Revision of TS6P01G - TS6P07G datasheet for outline dimensions P
Comparison report

Prepared by Riona
Checked by Celia
Approved by Celia
Issued date on April.7.2017
Revision for A

Subject: TS6P01G - TS6P07G

PACKAGE OUTLINE DIMENSIONS

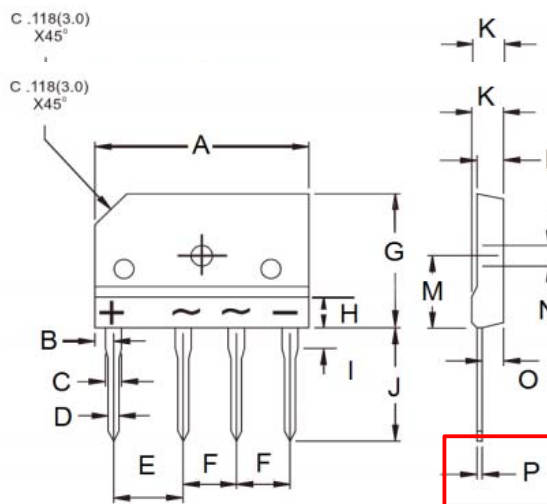
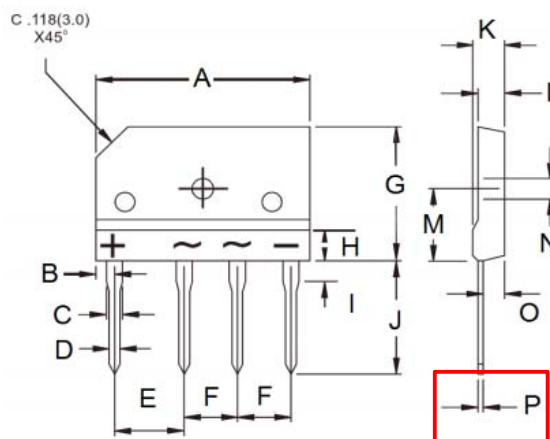
Correct package outline dimensions "P" →TYPO

DIM.	Unit (mm)		Unit (inch)	
	Min	Max	Min	Max
A	29.70	30.30	1.169	1.193
B	2.30	2.70	0.091	0.106
C	2.00	2.40	0.079	0.094
D	0.90	1.10	0.035	0.043
E	9.80	10.20	0.386	0.402
F	7.30	7.70	0.287	0.303
G	19.70	20.30	0.776	0.799
H	-	4.80	-	0.189
I	3.80	4.20	0.150	0.165
J	17.00	18.00	0.669	0.709
K	4.40	4.80	0.173	0.189
L	3.40	3.80	0.134	0.150
M	10.80	11.20	0.425	0.441
N	3.10	3.40	0.122	0.134
O	2.50	2.90	0.098	0.114
P	0.65	0.75	0.026	0.030
